## ANN ARBOR HISTORIC DISTRICT COMMISSION

### Staff Report

**ADDRESS:** 207 N Division Street, Application Number HDC25-0100

**APPLICATION:** The applicant seeks HDC approval to create a new opening on the north elevation to install an egress window

NEW NORTH ELEVATION

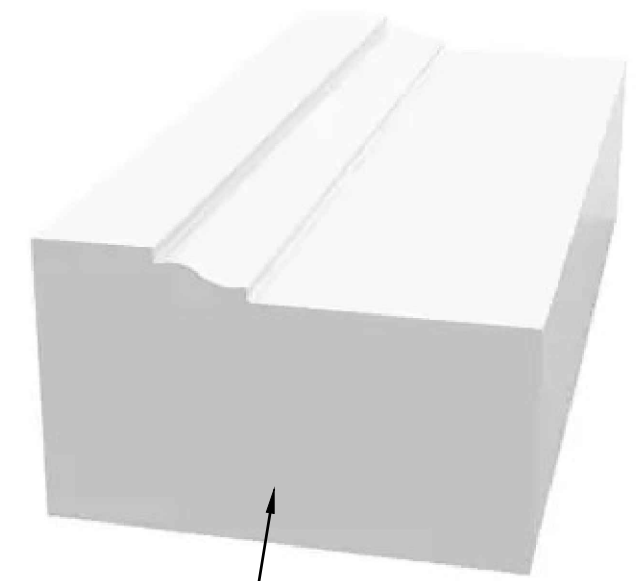
1. The applicant proposes creating an opening in the north elevation and adding an egress window to accommodate a new bedroom. It will be on the upper level, centered beneath the existing dormer. The new window will be set approximately 16 ft back from the corner of the east (Division Street-facing) elevation. It measures approximately 2 ft 5in by 3 ft and is smaller than the dormer window above it. The bottom of the new window will align with the bottom of the upper story window on the east elevation.

3. Staff believes this is an appropriate location for a new egress window. It will not be visible from the right of way because the house is set so far back from the sidewalk on Division Street, and there is little room between 207 N Division and the house to the north. The proposed size and trim are appropriate and differentiated from the historic.
